APPENDIX B  
TO  
FACILITY OPERATING LICENSE  
DPR-26

INDIAN POINT NUCLEAR GENERATING  
UNITS NUMBERS 1 AND 2

ENVIRONMENTAL TECHNICAL SPECIFICATIONS  
REQUIREMENTS

NOTE: *This document has been marked by Con Edison to indicate suggested changes to the Technical Specifications proposed by the AEC Regulatory Staff. Suggested deletions are indicated by hyphens and suggested insertions are indicated by italics.*

Figure - 29 Temperature sensor buoy system locations.

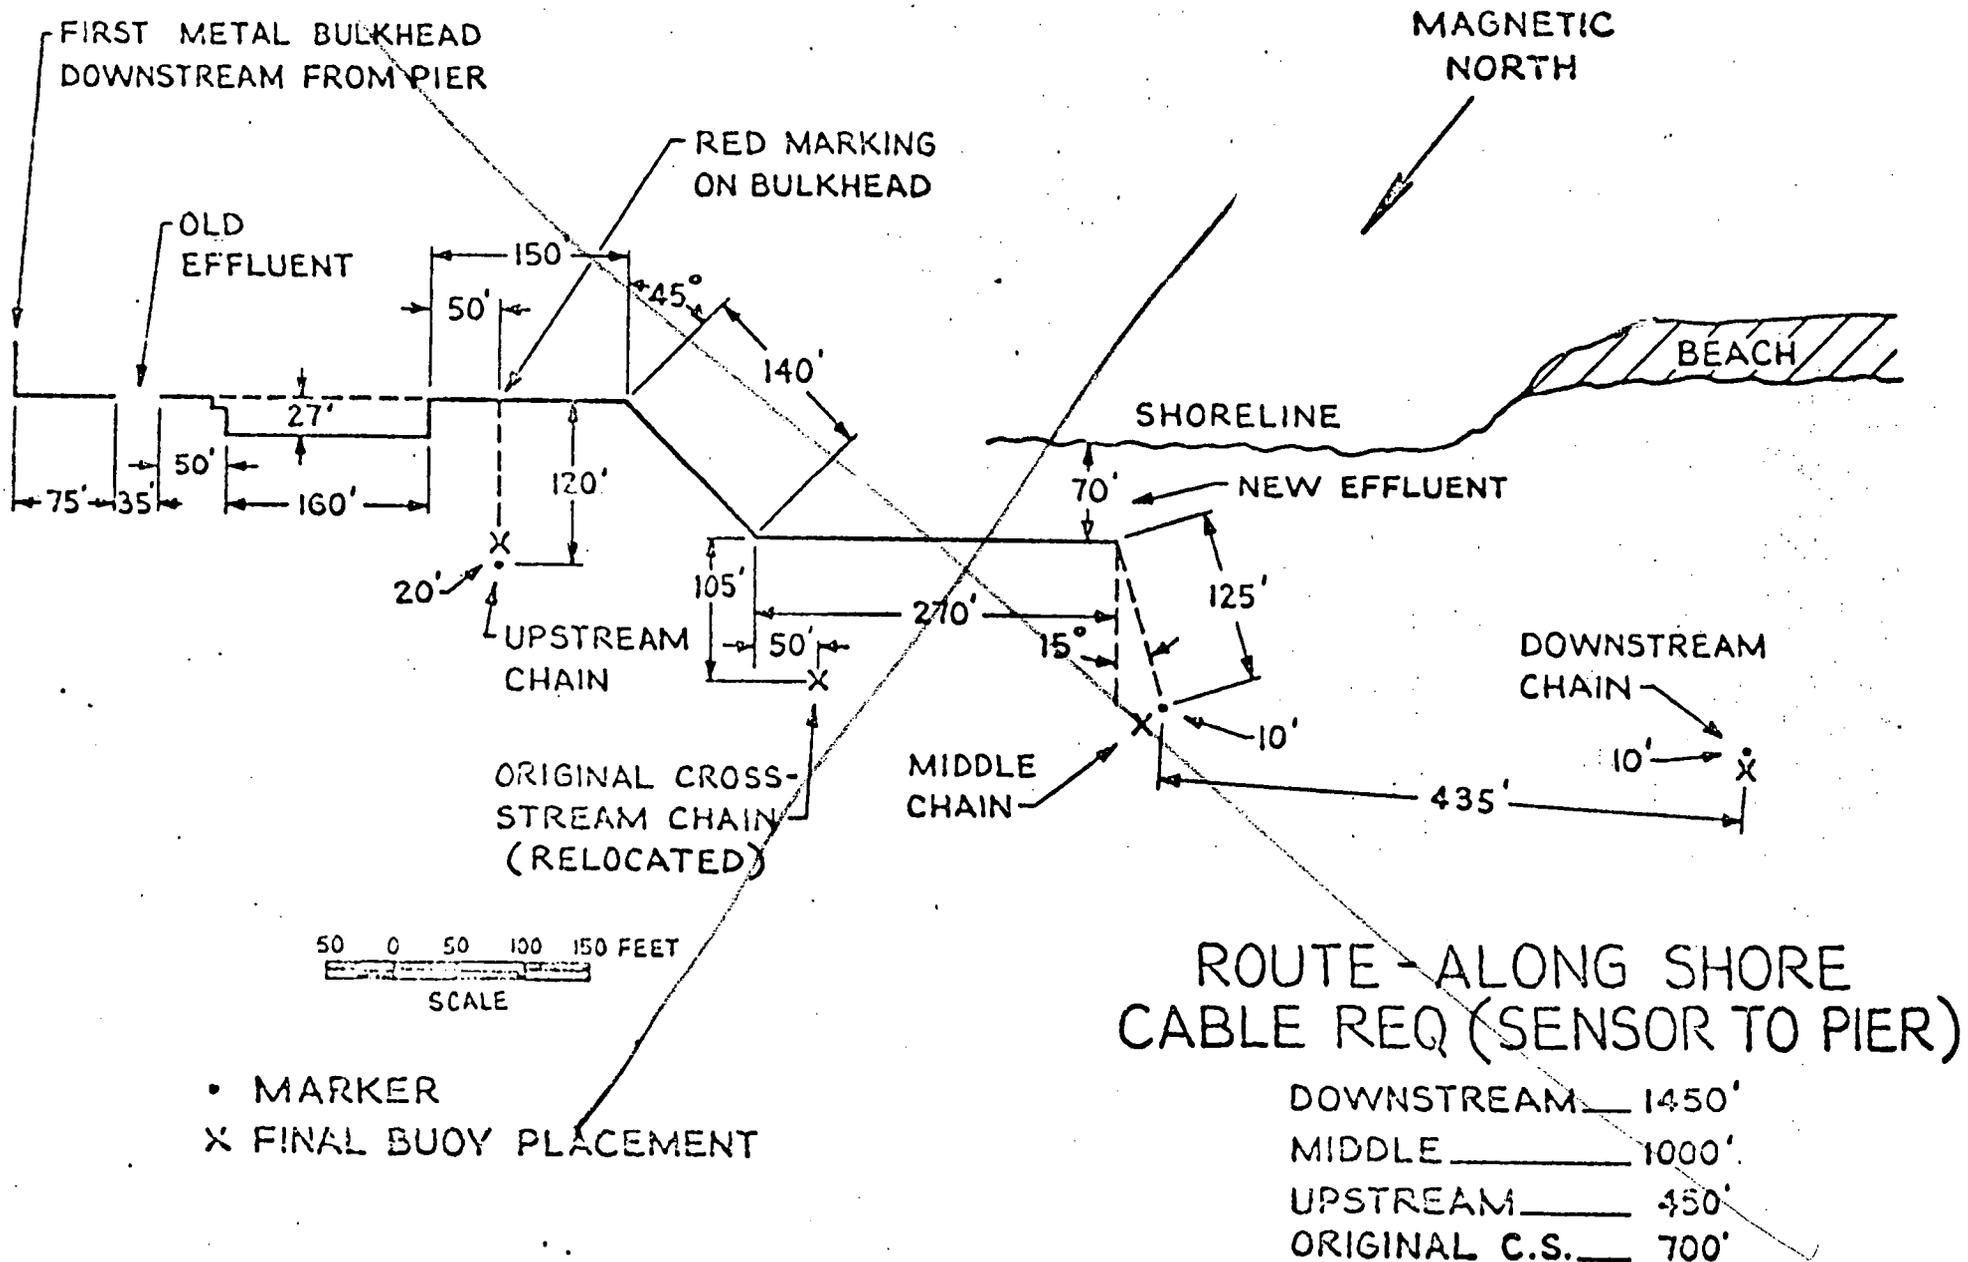
~~A Thermal Buoy System consisting of four buoys located at various distances upstream and downstream of the site shall record temperature continuously at the top, near top, near bottom, and the bottom of the river by means of thermistors. The probes are located at about 1450 ft downstream, 1000 ft middle, 450 ft upstream and 700 ft as shown in Figure 2-1.~~

Figure 2-1  
INDIAN POINT FACILITY

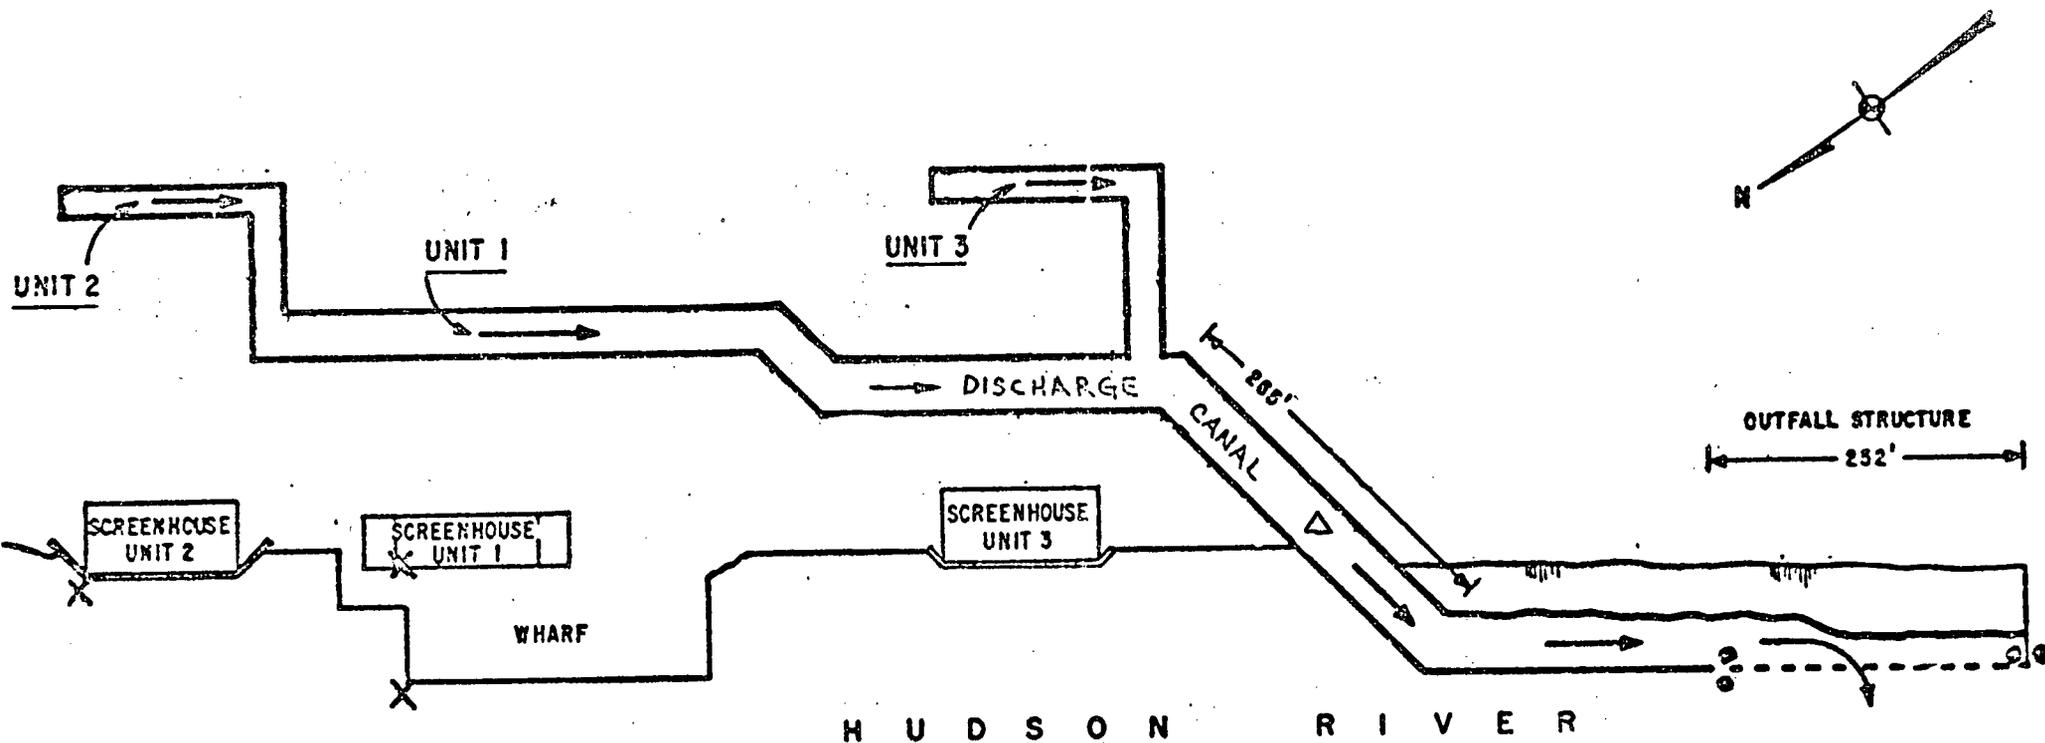
- 1.4.6 Site Background River Water Temperature - refers to a Hudson River Water temperature at the ~~Indian Point site without the addition of thermal discharges from the Indian Point site~~ edge of the dock, about 65 feet in front of the Unit No. 1 Intake structure. (See Figure 2-1.)
